NERPM Version 1.2

Summary of Changes

Appendix A

CR 16A and Johns Island Parkway subarea network and TAZ updates

19. Zone 1563 - centroid / connector relocation

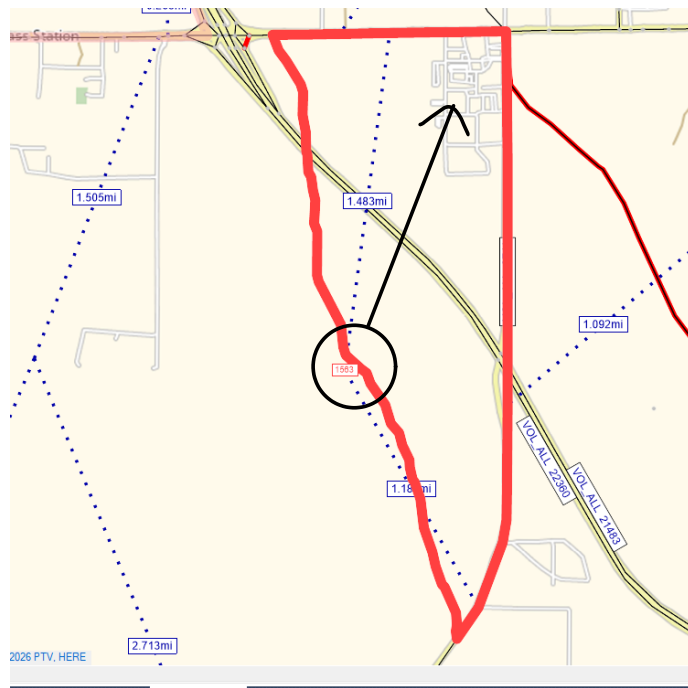
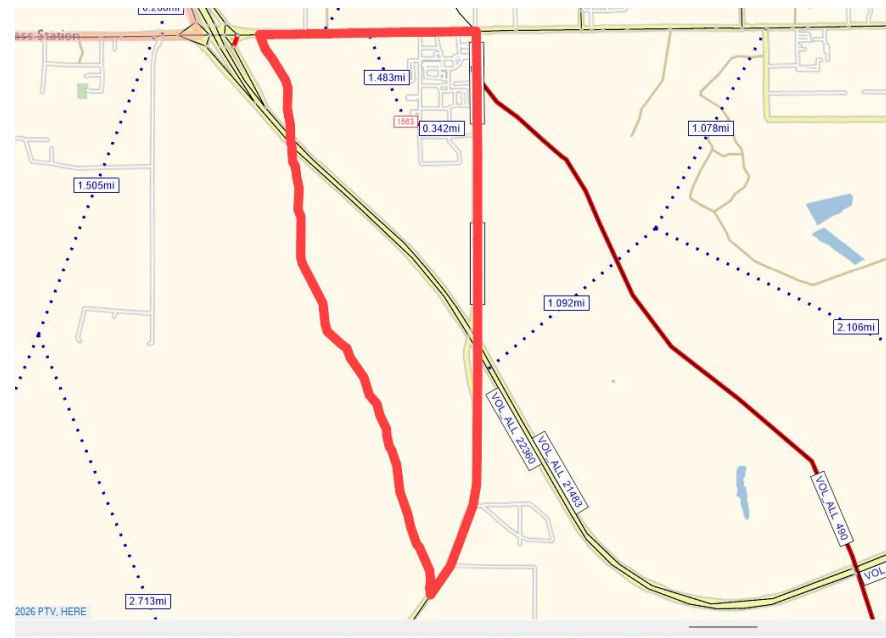
Network change: Zone 1563 centroid was moved closer to the served/developed area.

20. Zone boundary / connector restructuring

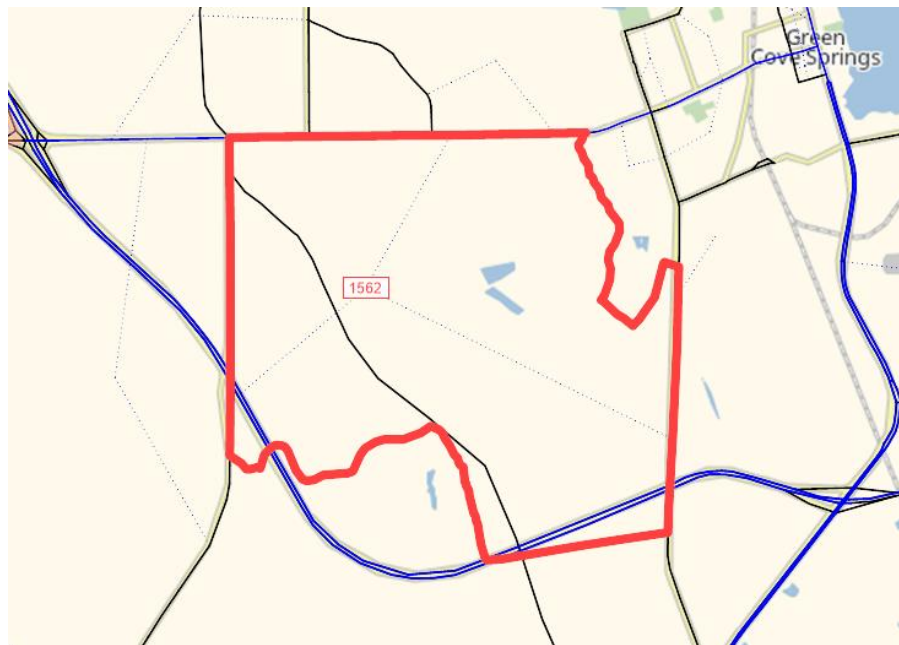
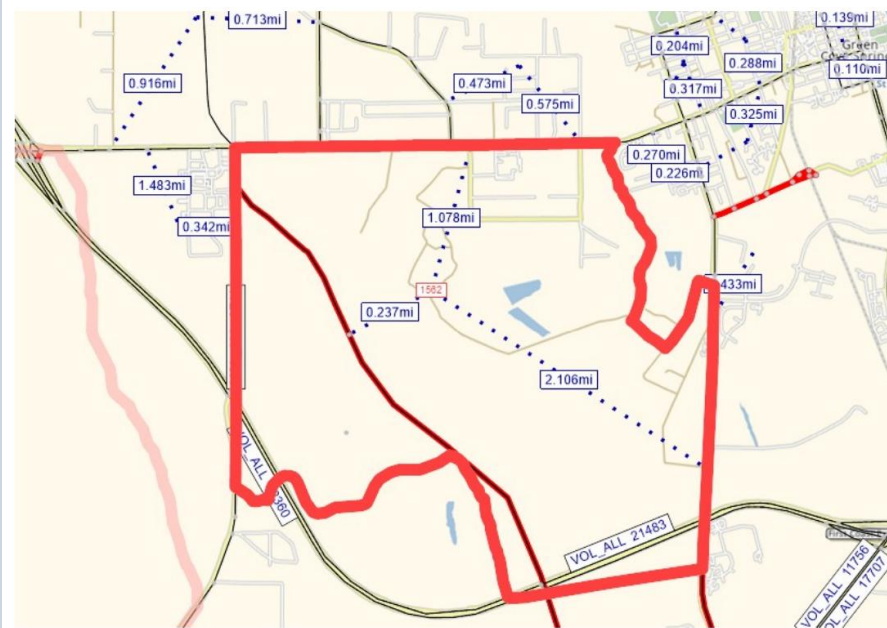
Network change: Zone boundary redrawn and centroid connector configuration updated.

21. First Coast Expressway interchange - connection geometry correction

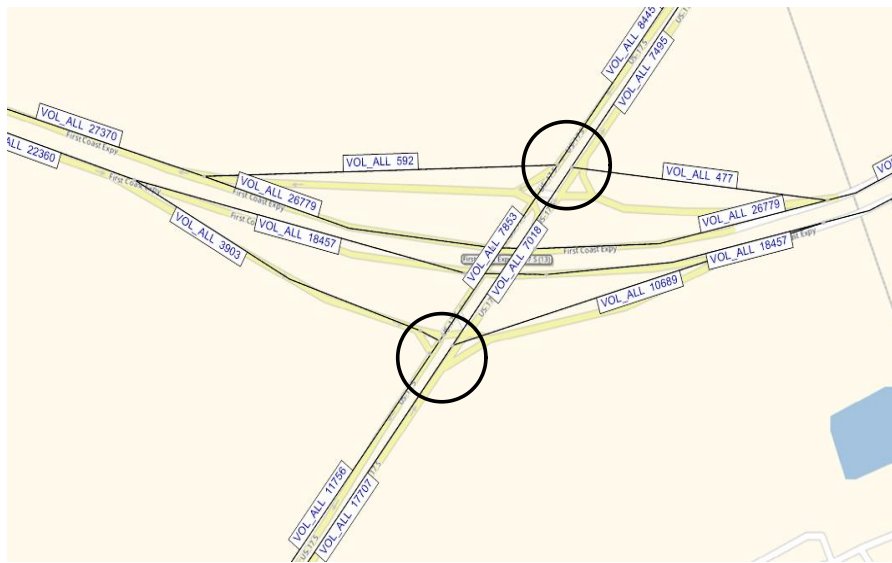
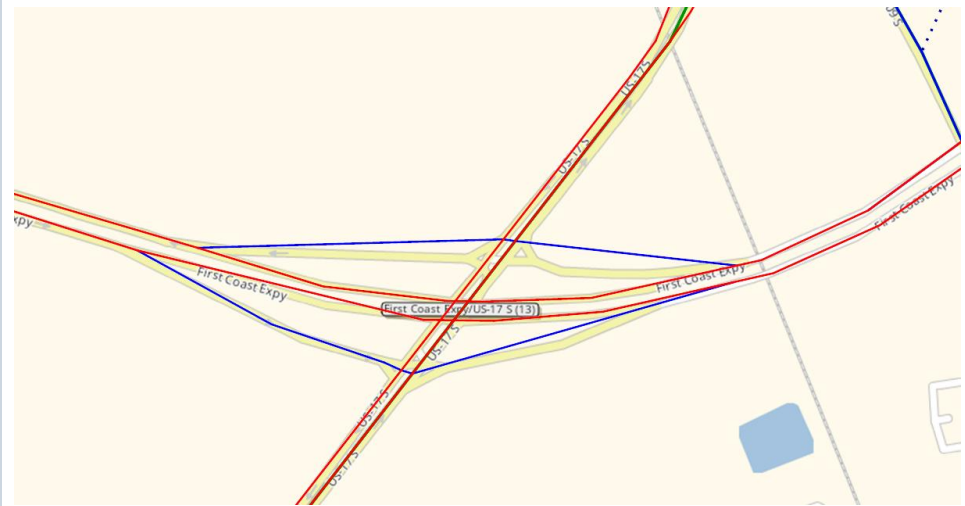
Network change: First Coast Expressway / US 17S interchange connection and turn points reconfigured to the corrected geometry..

22. Roadway link connection - Junction relocation

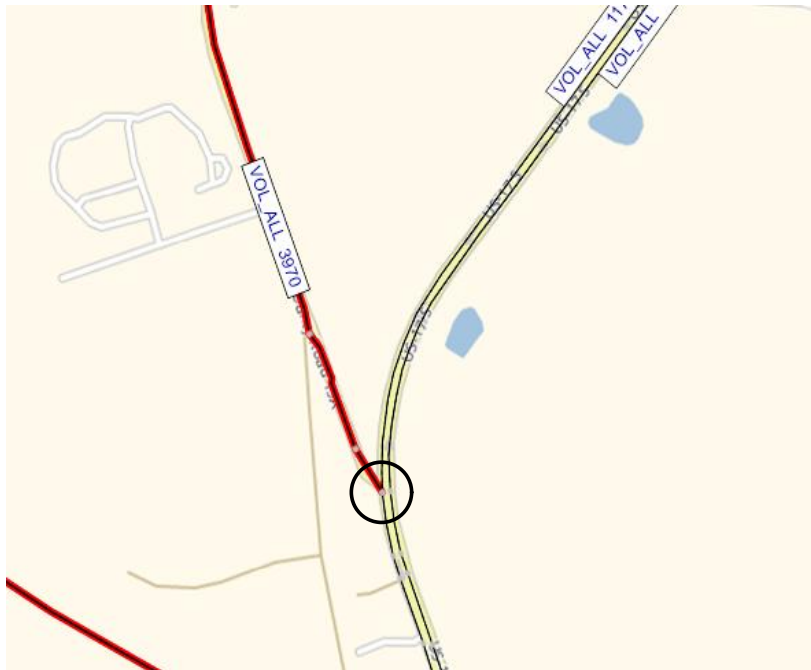
Network change: US 17 / County Road 15A intersection connectivity and geometry corrected.

25. Nocatee Parkway - turn penalties added

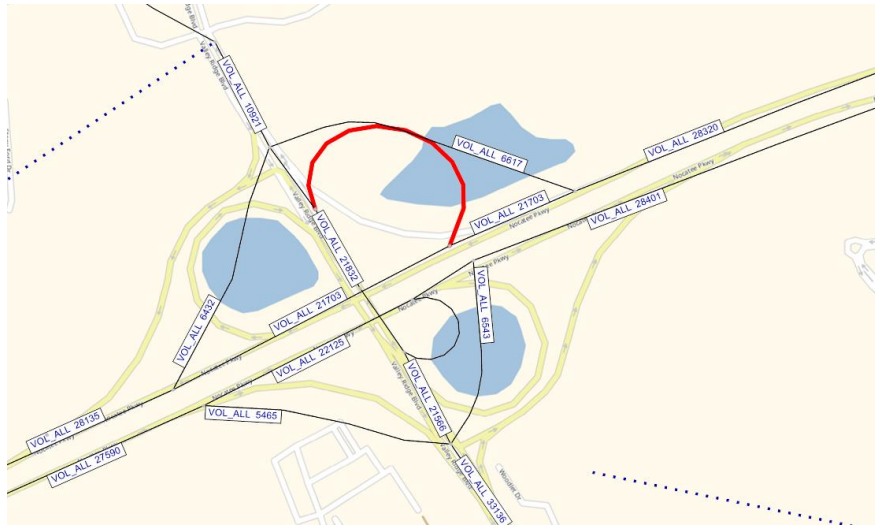
Turn prohibitions corrected at the Nocatee Parkway interchange at Valley Ridge Blvd.

26. 2050 SR 9 - lane correction (2 lanes to 3 lanes)

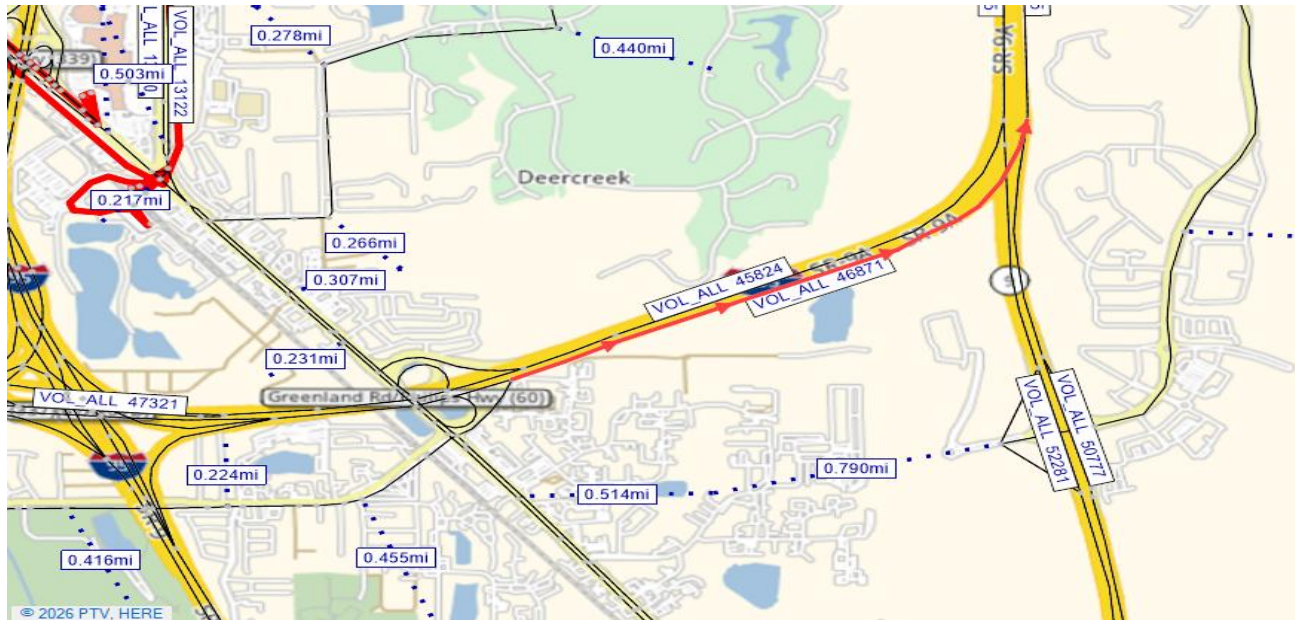
Network change: Selected 2050 SR 9 freeway links changed from 2 lanes to 3 lanes.

27. Collins Rd interchange - turn penalty added

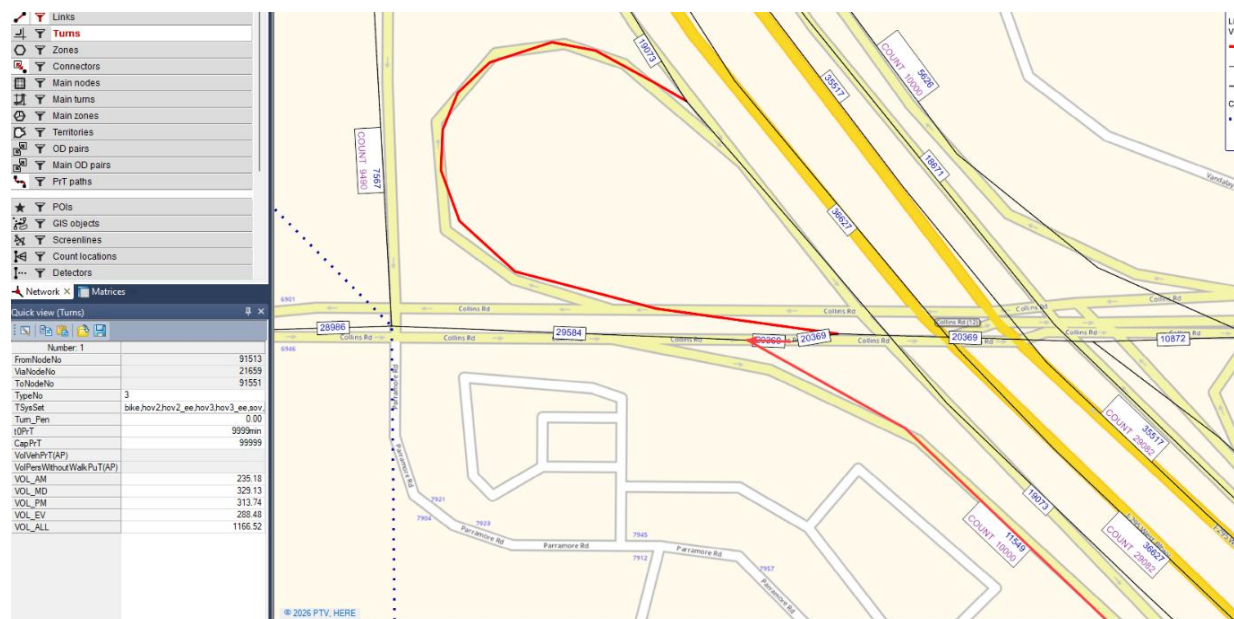
Network change: Turn prohibitions corrected at the Collins Rd interchange at First Coast Expressway.

28. County Road 209 S / First Coast Expressway - grade separation

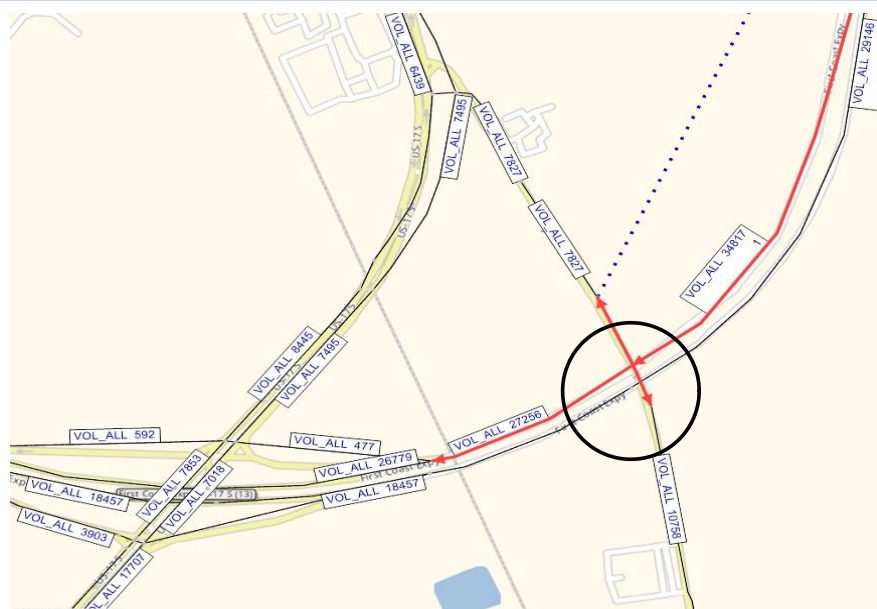
Network change: County Road 209 S / First Coast Expressway crossing recoded as grade separated, removing the at-grade connection.

Existing condition: The existing network connected the two facilities at the circled crossing, creating an at-grade intersection.

Update made: The crossing was grade separated, and the two facilities now cross without a direct at-grade node/turn connection.

Baldwin Bypass

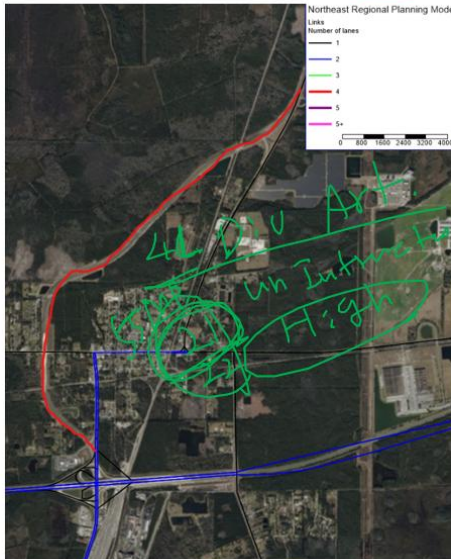
- Add the Baldwin Bypass as a 4-lane roadway to the 2030, 2040, and 2050 model networks.
- **Area Type: 21 (Central Business District Fringe Areas)**
- **Facility Type: 21 (Divided Arterial Unsignalized 55mph)**
- Add connectors to integrate the new roadway into the network.

- Comment: After reviewing google map, the road is open in 2021, consider adding the link in future year model.
- Question: -
- Action Item: Update Baldwin Bypass to 2030, 2040, and 2050 Model

Cisco Pritchard to 10

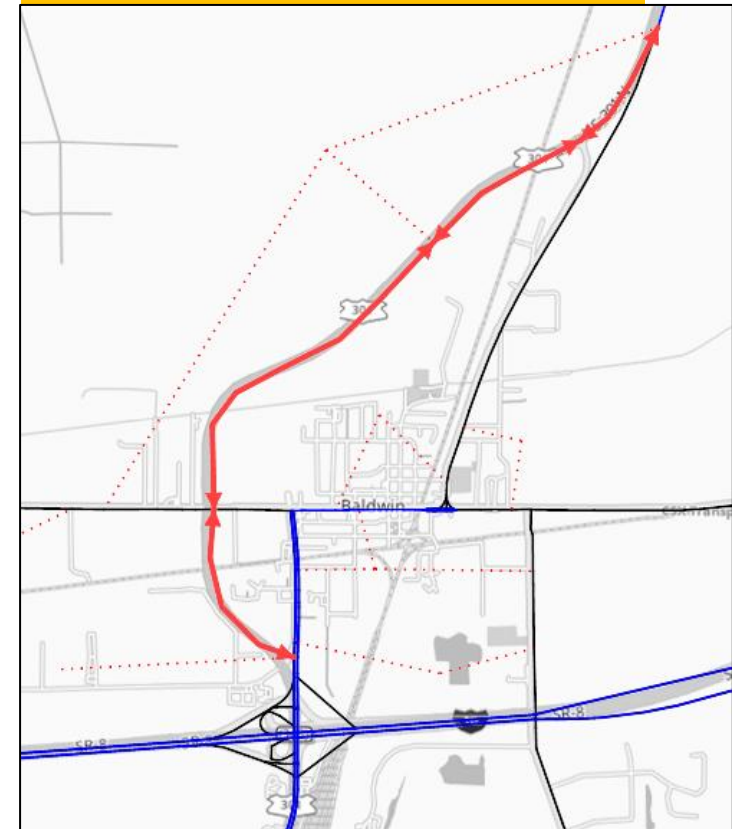
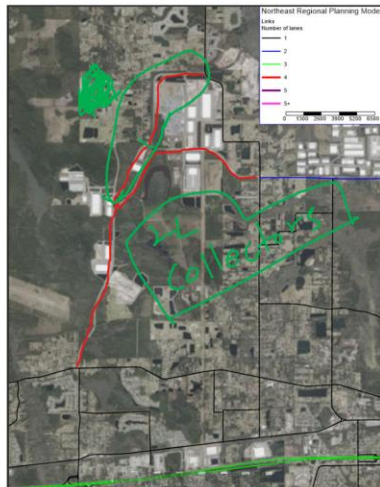
- Add the Cisco Pritchard to I-10 roadway as a 2-lane link in the 2020, 2030, 2040, and 2050 model networks.
- **Area Type: 31 (Residential Area of Urbanized Areas)**
- **Facility Type: 46 (Other Local Undivided Roadway without Turn Bays)**
- Add connectors to integrate the new roadway into the network.

- Comment: The 2020 and 2050 models will need to be updated based on Google Maps.
- Question: -
- Action Item: Update Cisco Prichard to 2020, 2030, 2040, and 2050 model

International Airport

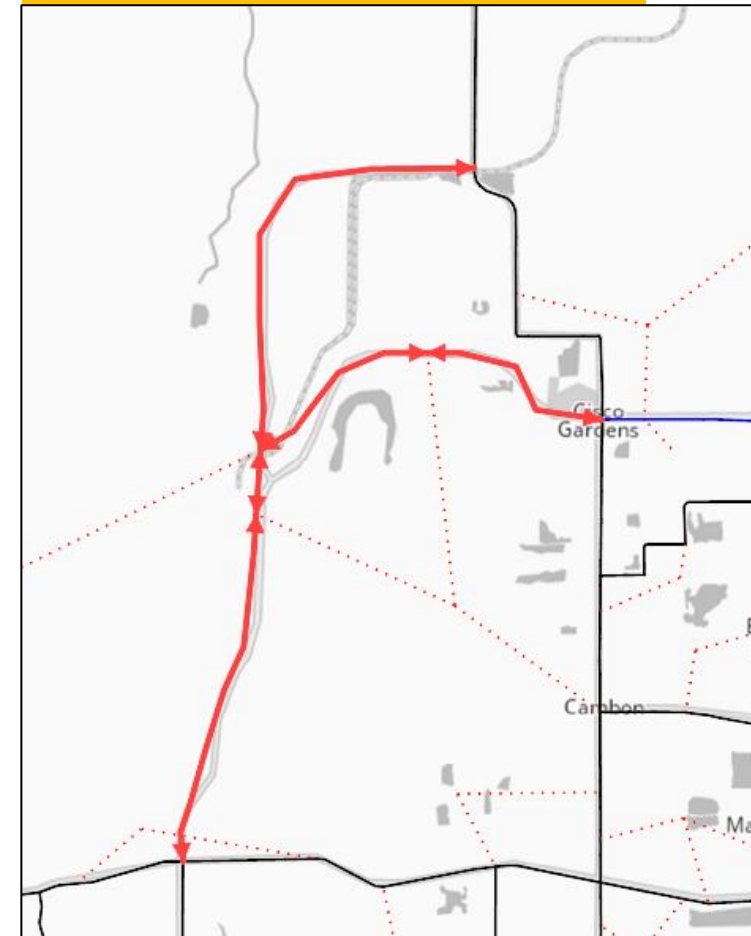
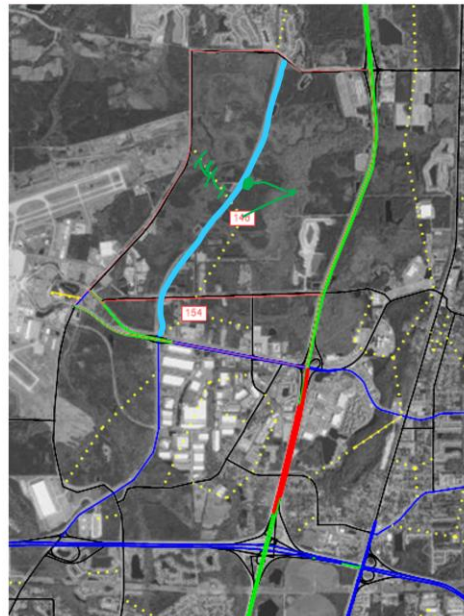
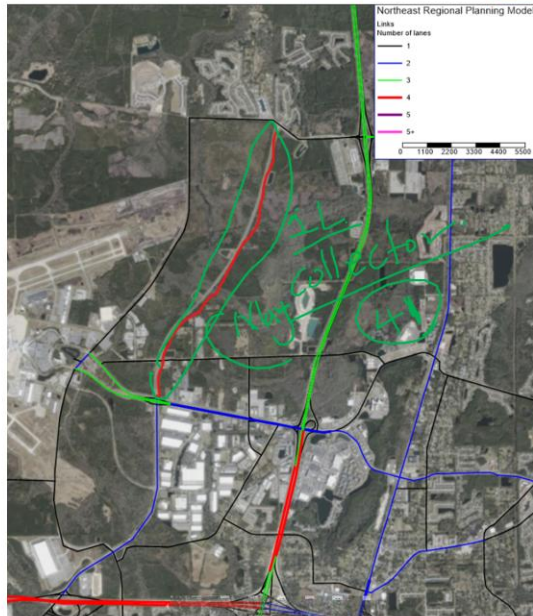
- Add the International Airport roadway as a 2-lane link in the 2020, 2030, 2040, and 2050 model networks.
- **Area Type: 31 (Residential Area of Urbanized Areas)**
- **Facility Type: 46 (Other Local Undivided Roadway without Turn Bays)**
- Add connectors to integrate the new roadway into the network.

- Comment: The 2020 and 2050 models will also need to be updated based on Google Maps.
- Question: -
- Action Item: Update International Airport Blvd Ito 2020, 2030, 2040, and 2050 model

Southeast Quad

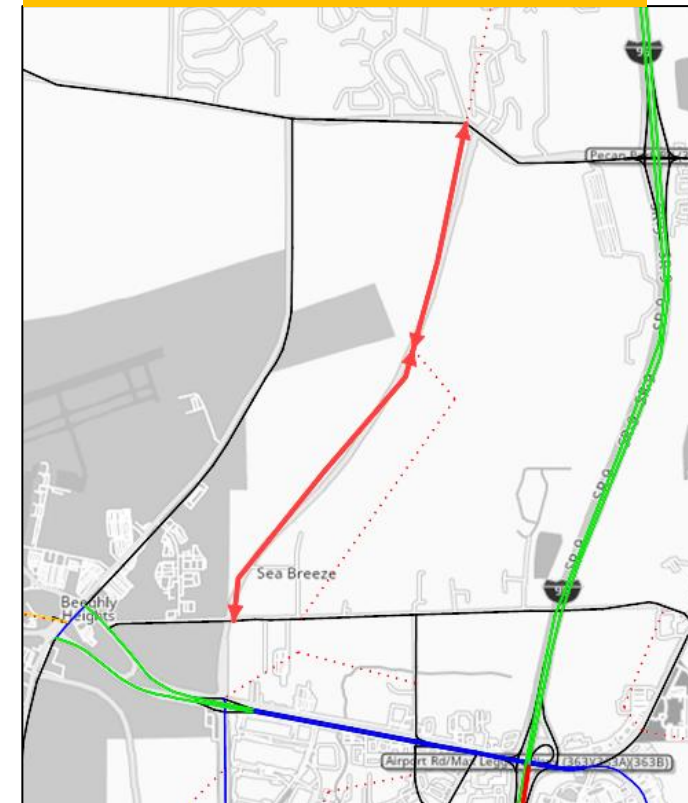
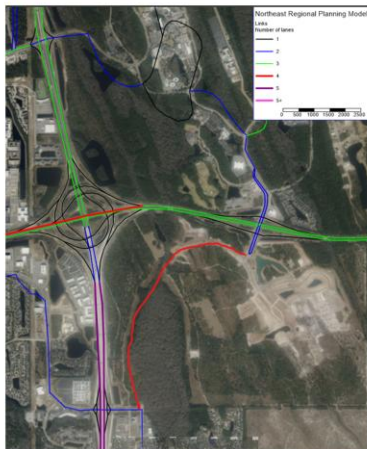
- Add the Southeast Quad area roadway as a 2-lane link in the 2030, 2040, and 2050 model networks.
- **Area Type: 31 (Residential Area of Urbanized Areas)**
- **Facility Type: 46 (Other Local Undivided Roadway without Turn Bays)**
- Add connectors to integrate the new roadway into the network.

- Comment: Based on the available information, the development is within the yellow -circled area, which is across **Zone 488** and **Zone 2049**.
- Question: : Is there a specific location or source that identifies the zone split boundary?
- Action Item: Split the zone in base-year and future-year models.

Cisco Pritchard Zone

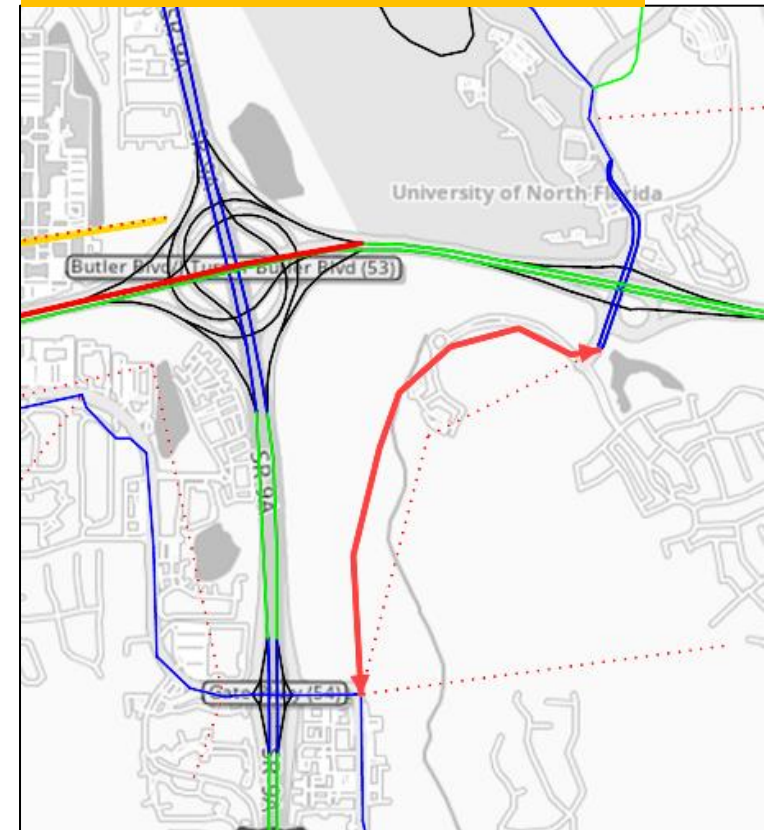
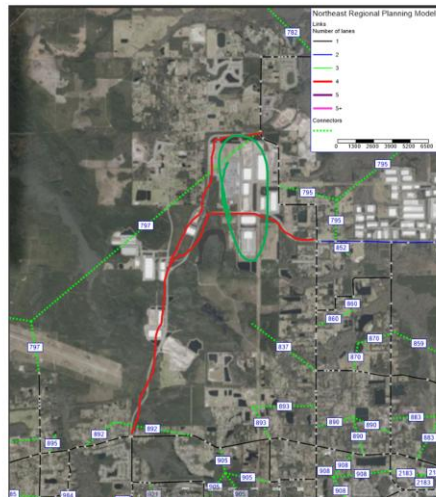
- Add new connectors to the Cisco Pritchard Zone

- Comment: Based on the available information, there is a development within the red-circled area, which is in **Zone 837**.
- Question: Is there a specific location or source that identifies the zone split boundary?
- Action Item: Split the zone in base-year and future-year models.
